Access Compliance Report

Public Rights-of-Way

(Curb Ramps)

Intersection ID: 10029623	Main Street: KING LOUIS CT	Cross Street: N/A	Location: W
ADA ID: FD97F1184D83	Ramp Type: ParaDiag	Initial Pass/Fail: Fail	Overall Compliance: No
Codes/Mitigation Info/Possible Solution		Field Measurements/Component Compliance	
Severity Score: 10

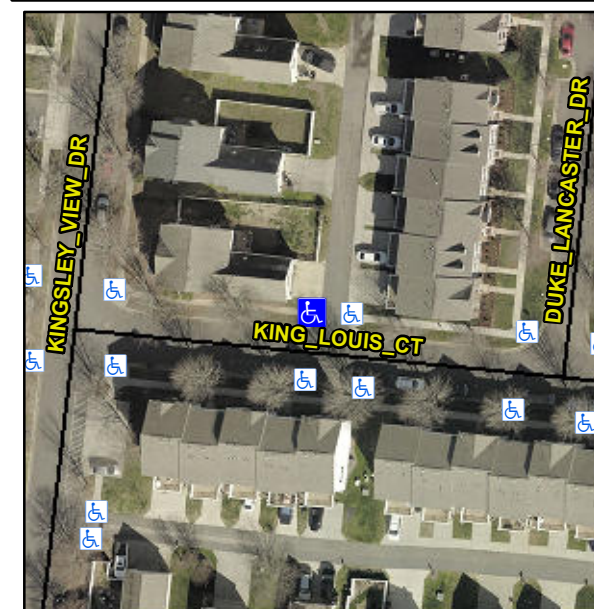
R304.5.1, R304.5.3

Compliance	Description	Data	Compliance	Description	Data
N/A	Ramp Length LT (in)	72.0	N/A	Ramp Length RT (in)	64.3
No	Ramp Width LT (in)	36.0	No	Ramp Width RT (in)	36.0
Yes	Ramp Slope LT (%)	5.6	Yes	Ramp Slope RT (%)	6.4
No	Ramp XSlope LT (%)	2.2	No	Ramp XSlope RT (%)	3.2
N/A	Landing Length (in)	N/A	N/A	DWS Provided?	N/A
N/A	Landing Width (in)	N/A	N/A	DWS Contrast?	N/A
N/A	Landing Slope (%)	N/A	N/A	DWS Length (in)	N/A
N/A	Landing X Slope (%)	N/A	N/A	DWS Full Width?	N/A
N/A	Landing Curb? (Y/N)	N/A	N/A	DWS Offset (in)	N/A
N/A	Shared Landing?	N/A			
N/A	Gutter Ponding?	N/A	N/A	Gutter Slope (%)	N/A
N/A	Gutter Lip Ht (in)	N/A	N/A	Gutter X Slope (%)	N/A
N/A	Painted X Walk1?	No	N/A	Painted X Walk2?	No
	X Walk 1 Direction	To S		X Walk 2 Direction	To E
N/A	X Walk 1 Width (in)	N/A	N/A	X Walk 2 Width (in)	N/A
	X Walk 1 Slope (%)	1.0		X Walk 2 Slope (%)	2.6
	X Walk 1 X Slope (%)	3.4		X Walk 2 X Slope (%)	3.2
N/A	Ramp inside XWalk1?	N/A	N/A	Ramp inside XWalk2?	N/A

Remove & Replace Curb Ramp With Two New Directional Ramps or Equivalent.
